Addendum #2

RE: QUESTIONS & ANSWERS, SPECIFICATIONS, DRAWINGS AND DOCUMENTS

Project
SICKKIDS - 7A SCHEDULE - 1BEDS REFRESH
ATRIUM (SLAUGHT) WING, 170 ELIZABETH STREET, TORONTO, ON, M5G 1E8

7 SHOWER -PATIENT WASHROOM ELEVATION
 SCALE: 1:20

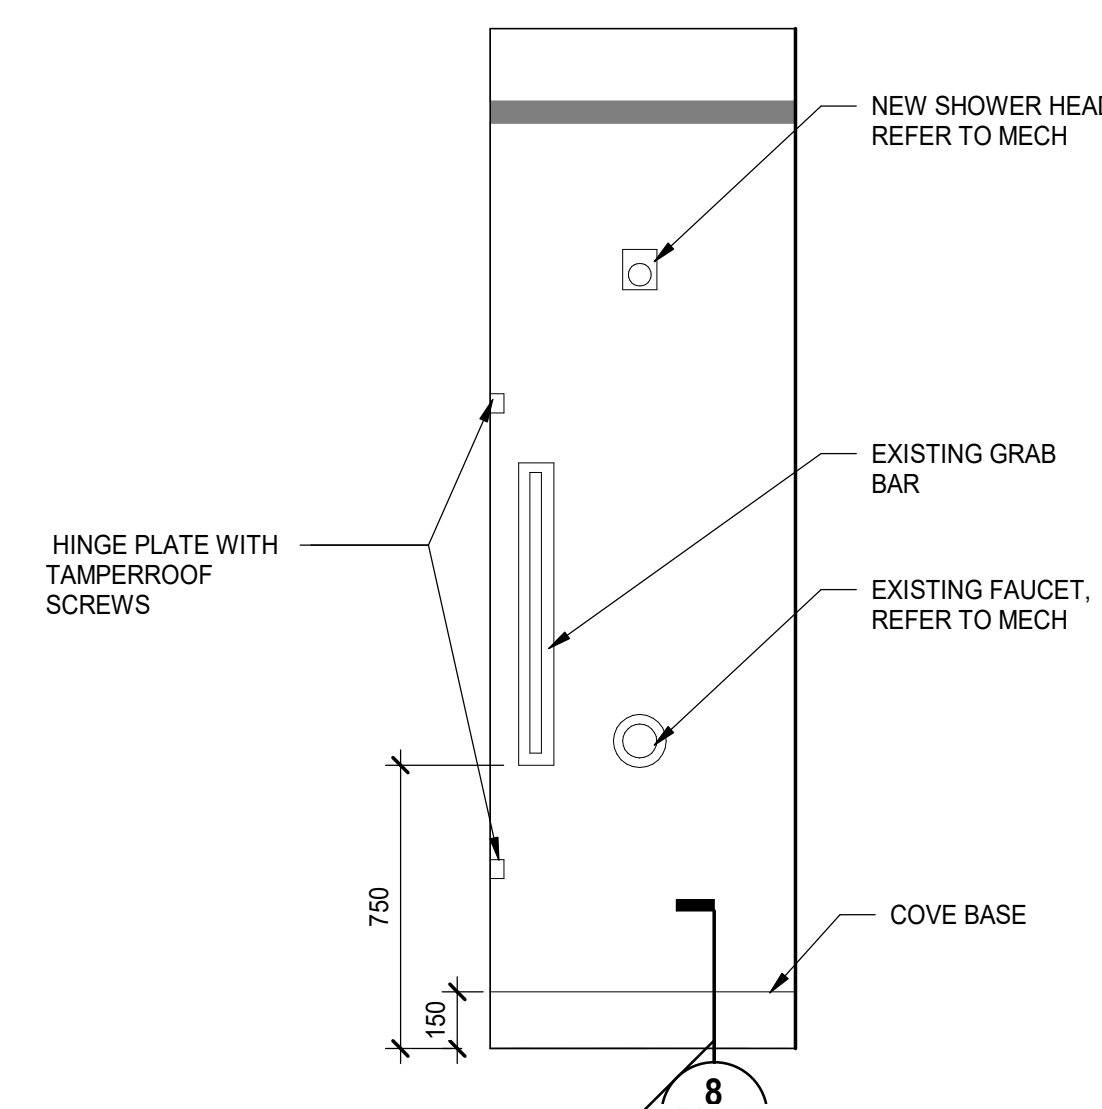
Q72- Furniture & Equipment Plan Notes shows shower panel by SickKids, however a specification for an anti-ligature safe door is provided. That being said, please clarify elevation 7/AF MN AN 02. There appears to be 2 panels on hinges. Are both SK-06. Is SickKids supplying both panels? Is there a third panel in between? From the floor plan, there appears to be 1.6m of space (5'3"), however the anti-ligature safe doors are 36" each plus 2" for the hinges, so one door alone will be just under 1m, not leaving enough space for 2. Please clarify the intent here and who is responsible for the supply.

6 TYPICAL WINDOW S2 SECTION DETAIL AT CORRIDOR WINDOW
 SCALE: 1:10

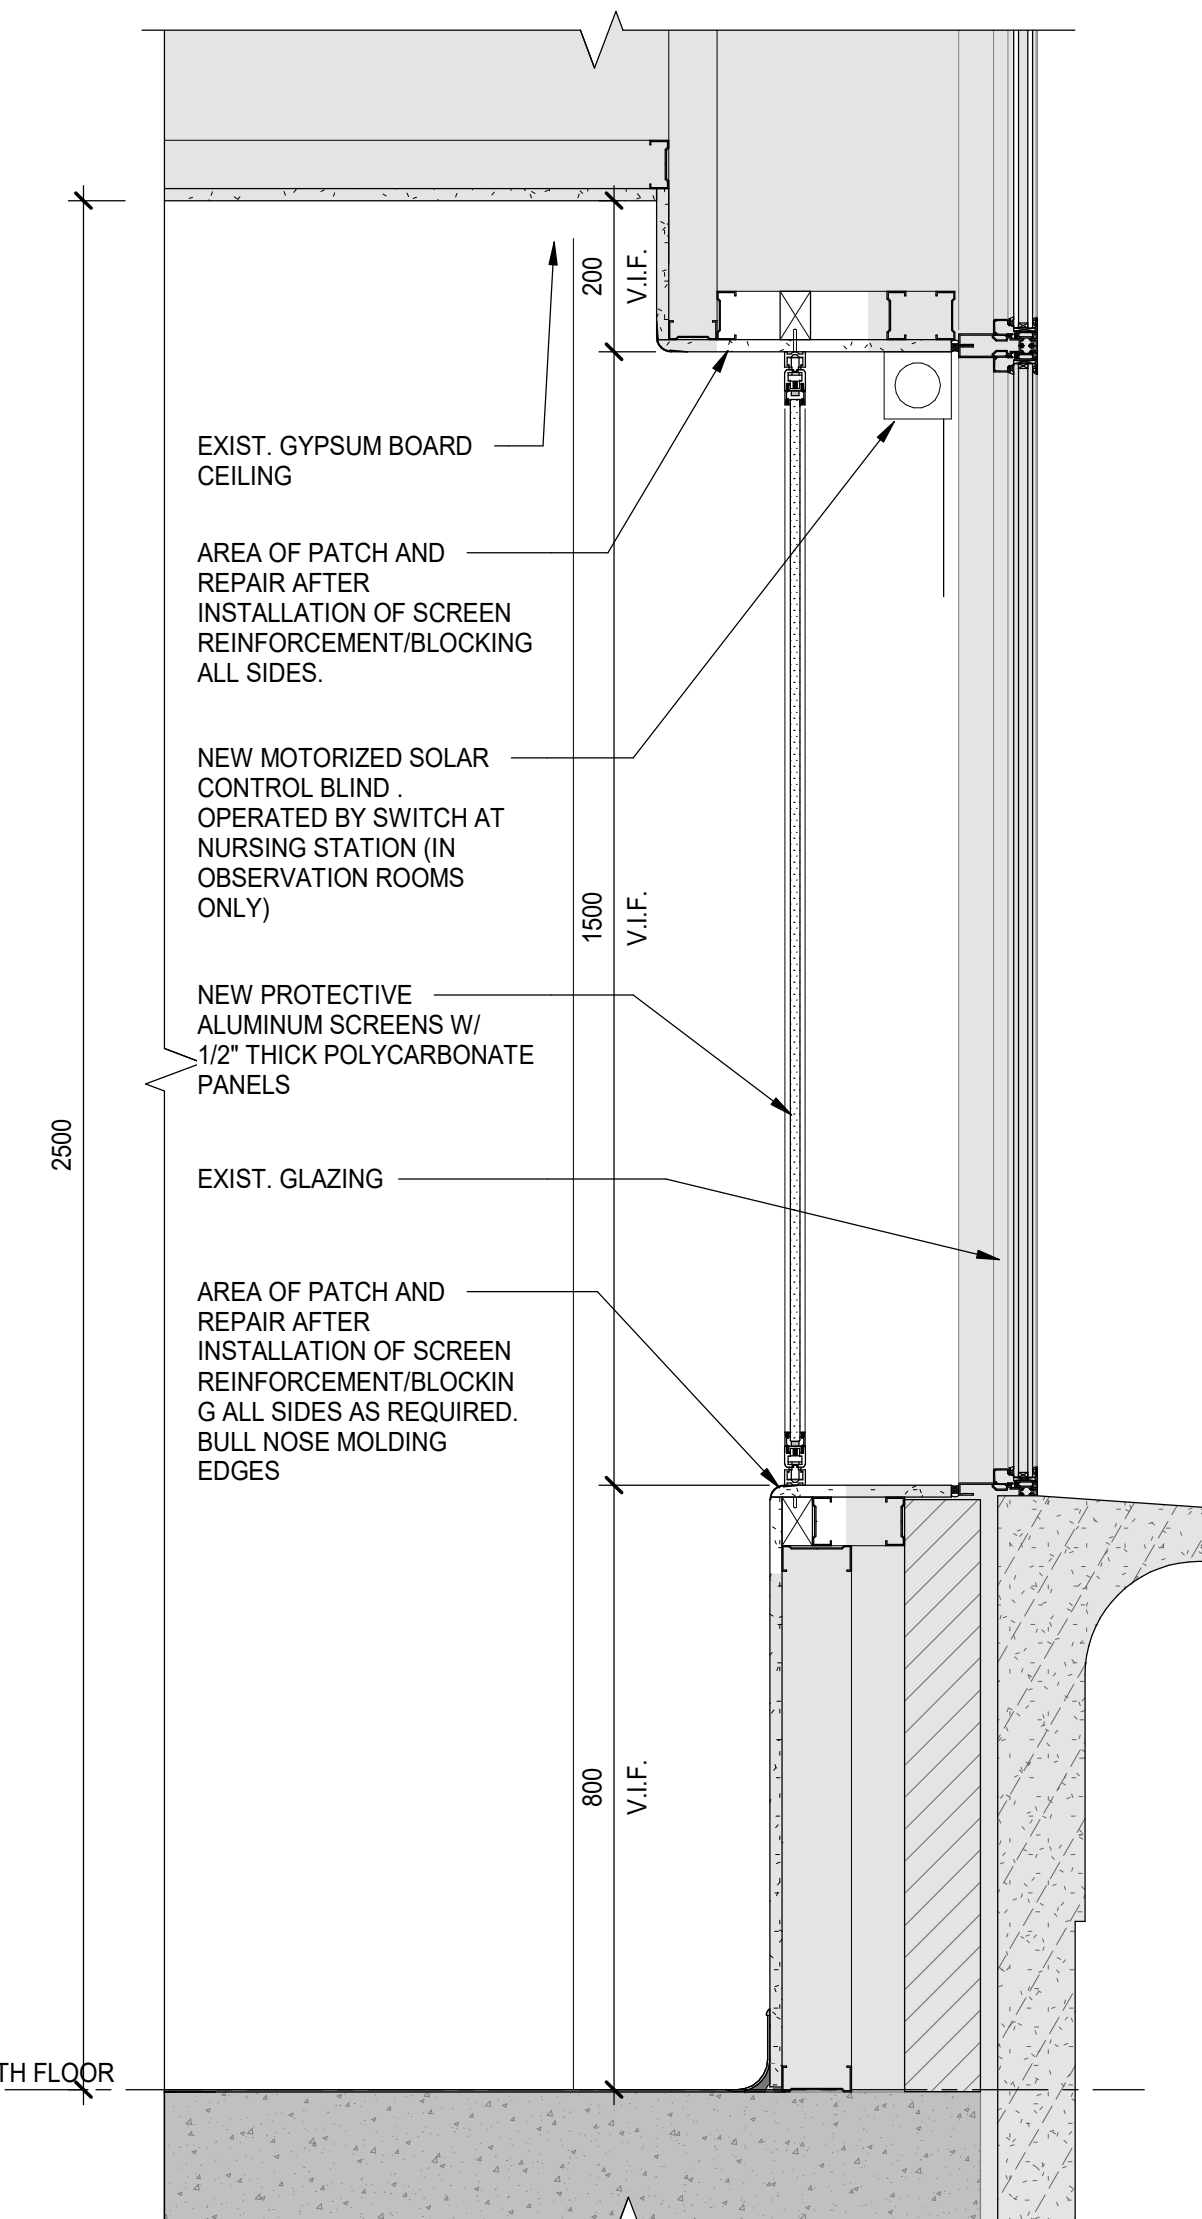
Q59- Please clarify if all three S2 screens are to be operable or if the 2 outer S2 screens are to be fixed as per elevation detail 6/AFMNAN02. Please also clarify if operable panel of screen S1 is to be on the left side (as per elevation) or right side (as per plan).

A59- Refer to revised Drawings issued as part of Addendum 2, all protective screens will be operable.

4 6TH FLOOR PARTIAL PLAN
SCALE: 1:50

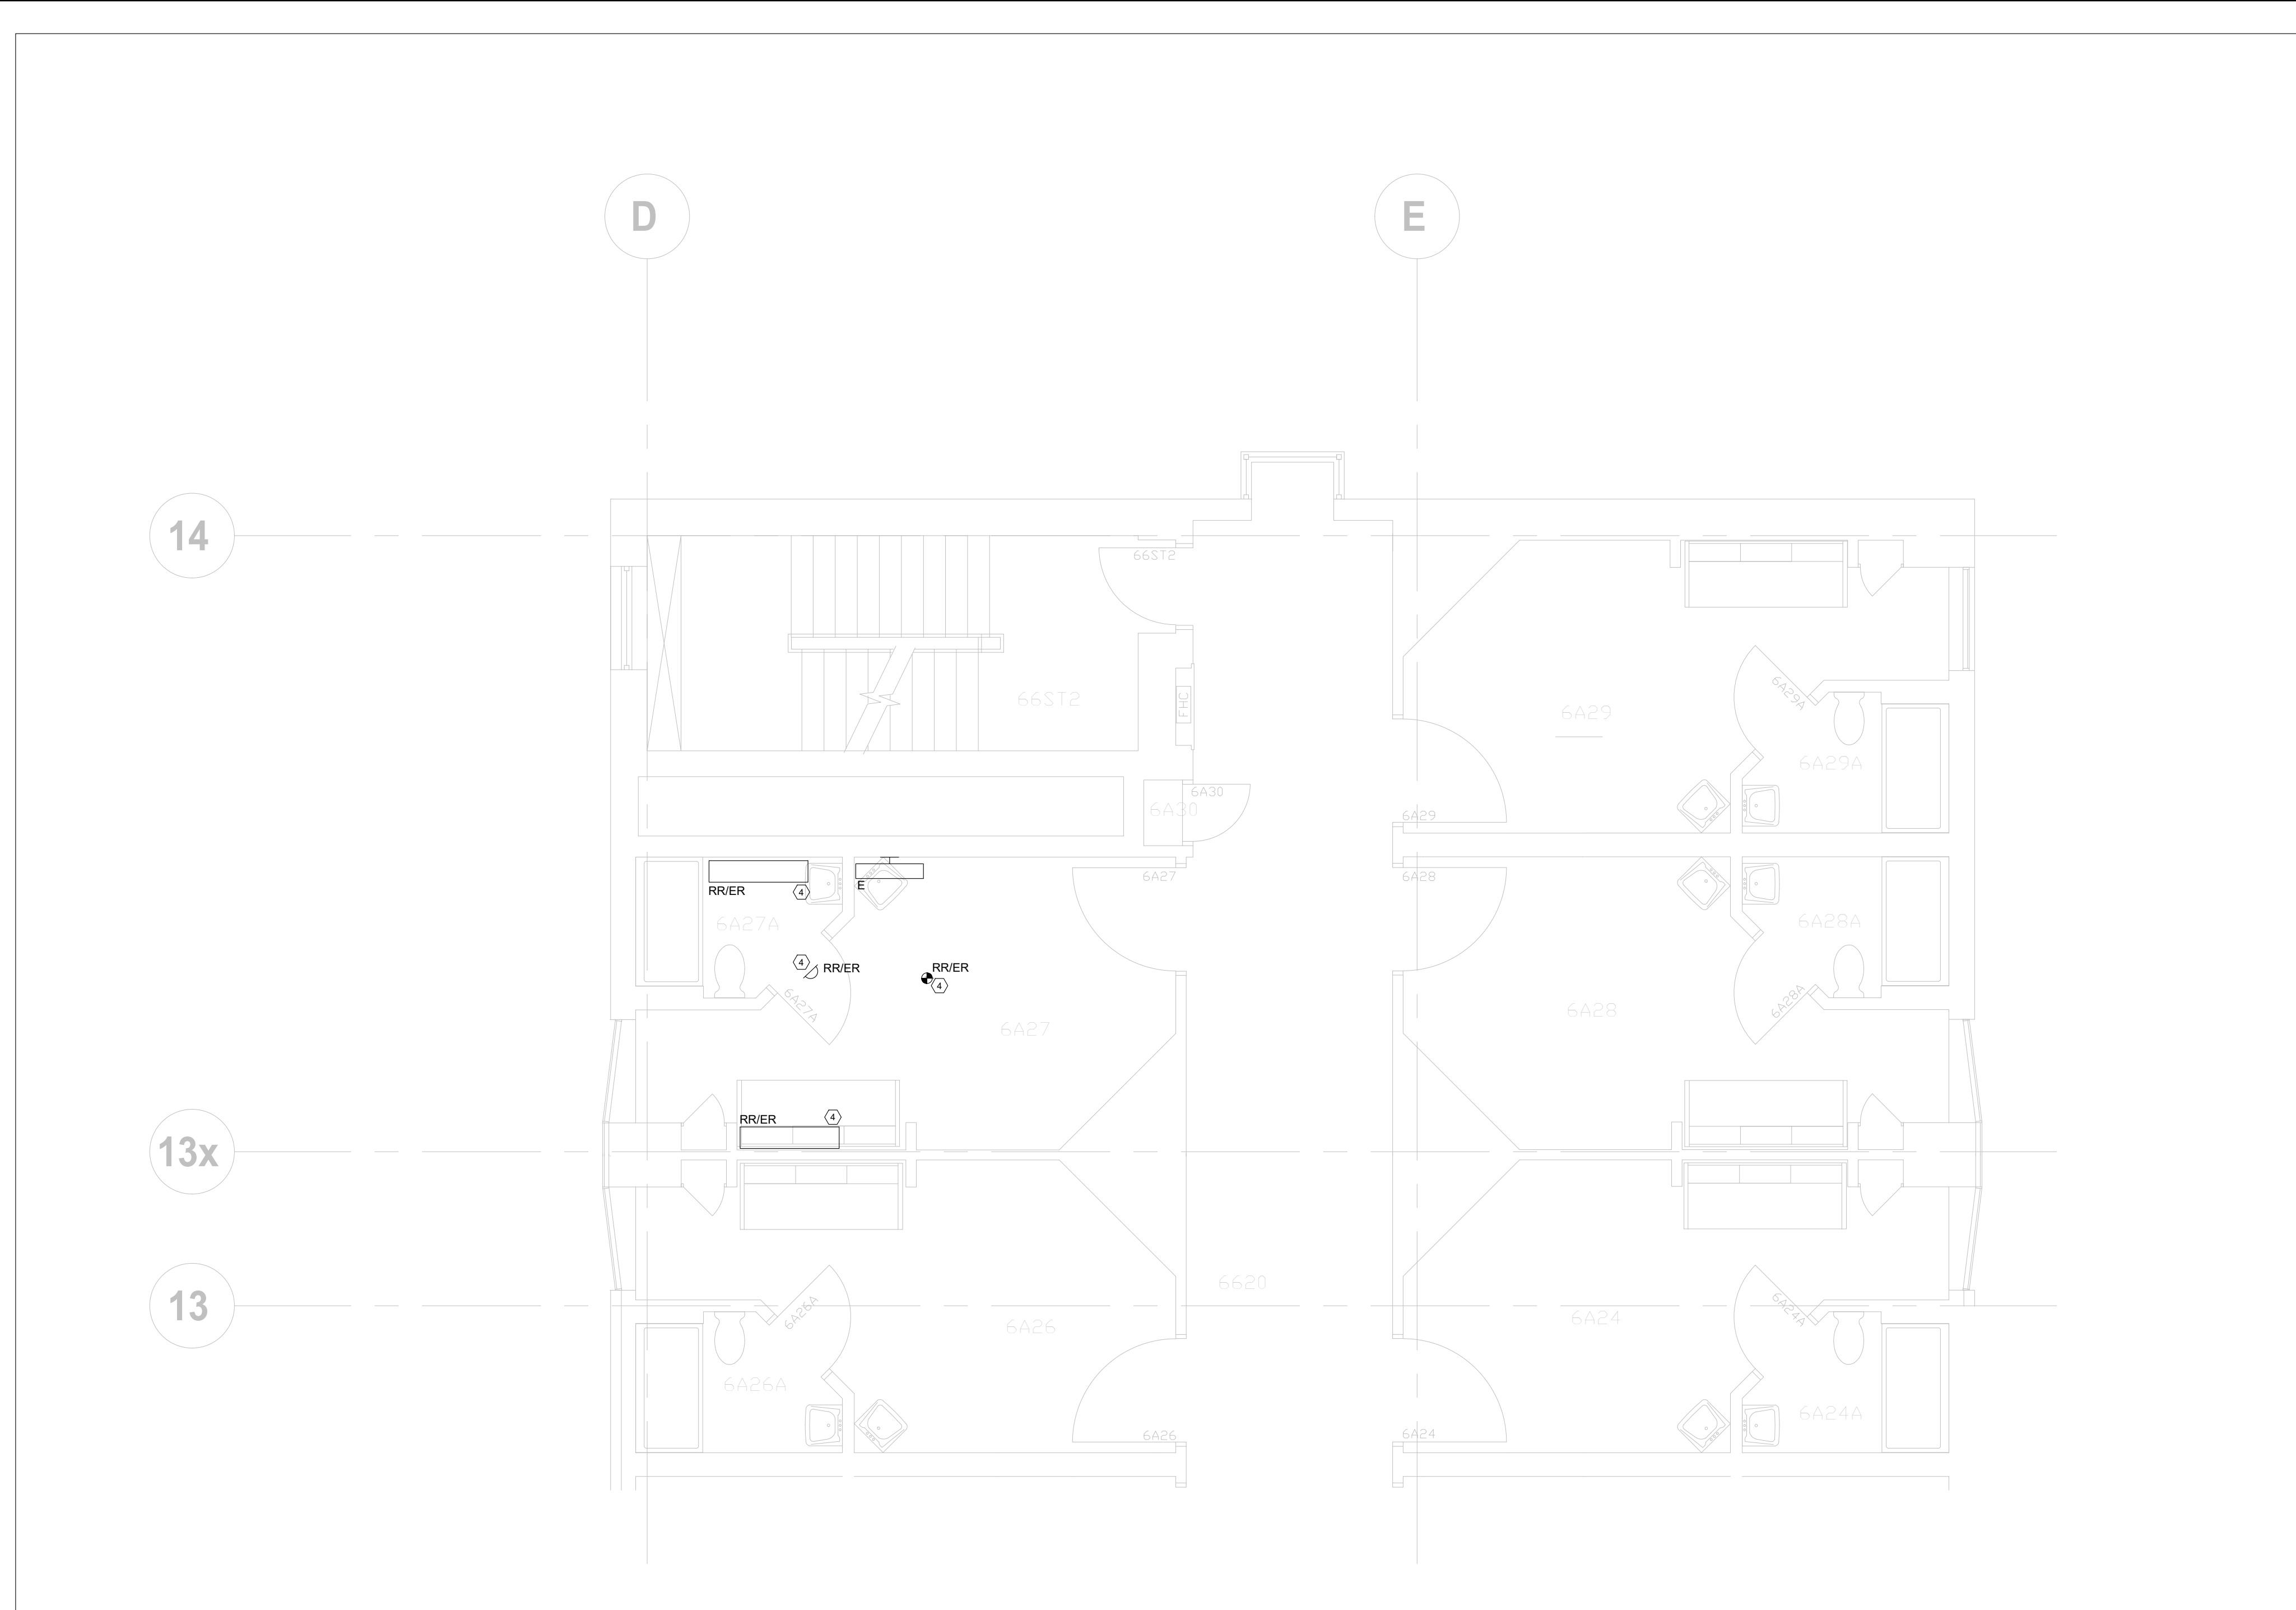
- Q11- Please clarify access to the 6th floor. Mechanical drawings have a note that in part reads "... access to level 6 is not available", yet electrical plan detail 4/EP 07 AN 01 is a 6th floor plan that note #4 calls for removal & reinstatement of electrical devices for vent work.**
A11- Level 6 scope of work included as part of Separate price. Mechanical drawings will be updated to suit as part of Addendum (Drawing MP 07 AT 01, MV 07 AT 01).
